**Marion County
Board of County Commissioners**

**PLANNING & ZONING SECTION
STAFF REPORT**

P&ZC Date: 04/28/2025	BCC Date: 05/19/2025
Case Number	250507ZP
CDP-AR	32481
Type of Case	Rezoning from Single-Family Dwelling (R-1) to Planned Unit Development (PUD) for a maximum of 151 multi-family dwelling units.
Owner	Lake Louise, LLC.
Applicant/Agent(s)	Kimley-Horn & Associates, Inc.
Street Address / Site Location	No site address
Parcel Number	3060-007-004, 3060-004-001
Property Size	±9.51 acres
Future Land Use	Urban Residential (UR)
Zoning Classification	Single-Family Dwelling (R-1)
Overlay Zone/Scenic Area	Urban Growth Boundary (UGB), Primary Springs Protection Overlay Zone (PSPOZ)
Staff Recommendation	DENIAL
P&ZC Recommendation	TBD
Project Planner	Kathleen Brugnoli
Historic/Related Case(s)	190711SU: Hay Production in R-1 – Approved; 22-S08: Small Scale Map Amendment from Medium Residential (MR) to Urban Residential (UR) – Approved.

Figure 7
Lake Louise Site Plan

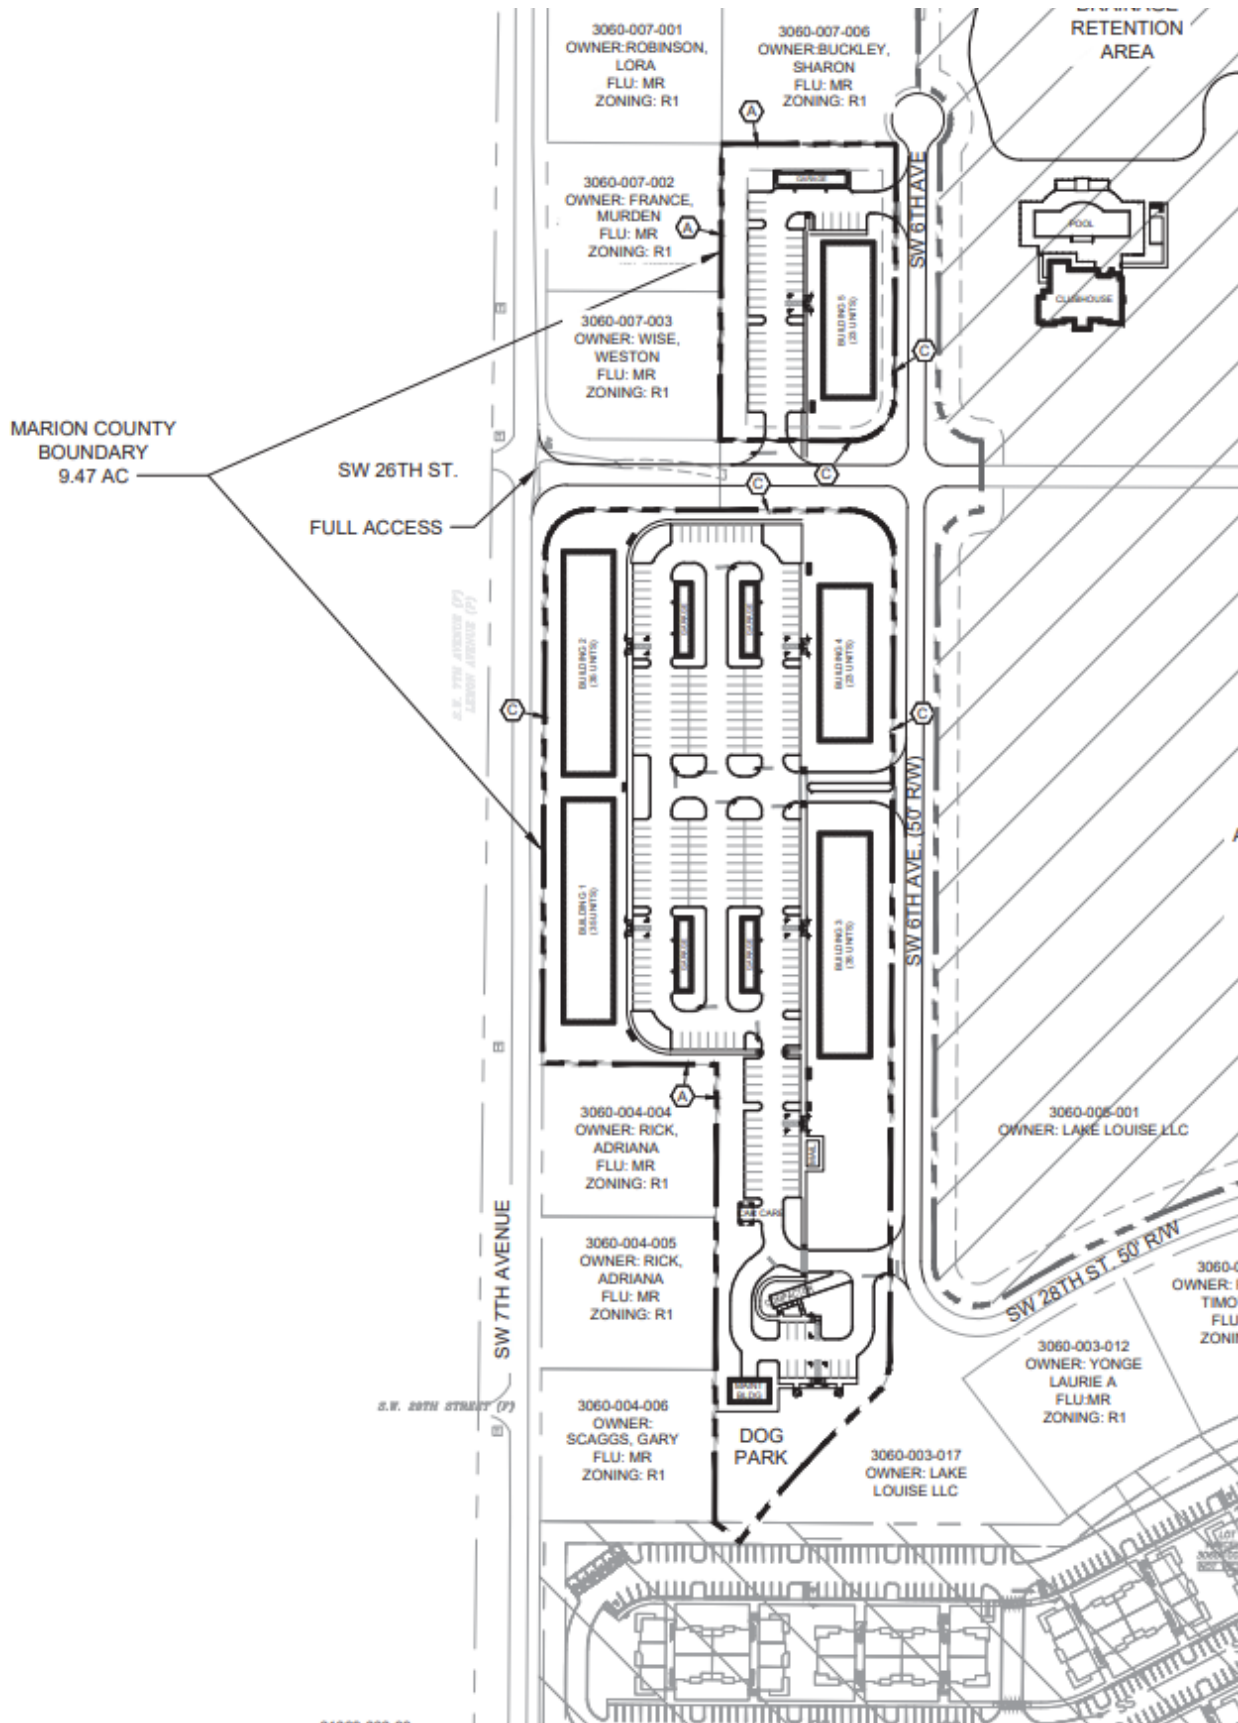
The plan proposed includes three 35-unit structures and two 23-unit structures. The maximum building height provided would be 40' with a required minimum 30' separation between the buildings.

Analysis: Stormwater review shall take place during the Major Site Plan review process which must occur prior to construction. However, the site plan provided currently includes no stormwater facilities on-site. Thus, the application is **not consistent** with SE Policy 1.1.5.

Analysis: Stormwater was not addressed with the application and doesn't appear to be shown on the site plan provided. The application is **not consistent** with this section.

Analysis: Stormwater management facilities are not addressed with the site plan or development standards. The application is **not consistent** with this section.

Analysis: The PUD Plan proposes the sites various setbacks, height, and floor area ratio amounts in a table format but does not provide a typical illustration showing these. The PUD is **not consistent** with this section

Analysis: The PUD plan states the minimum 20% open space will be provided but does not give detailed figures or list the areas being designated for open space on the site plan. The application is currently **not consistent** with this section of the LDC as there are no figures provided to confirm the minimum open space requirement.

6. Sidewalk to be provided internally as shown in the PUD site plan.
7. Sidewalk shall be provided along SW 7th Ave.
8. The DRA will be required hold the total stormwater runoff volume generated from the 100-year, 24-hour storm event, with no off-site discharge.

10. The PUD must meet the LDC requirement of a minimum of 20% improved open space.
11. The final PUD master plan must be brought back and heard by the Board of County Commissioners for final approval.
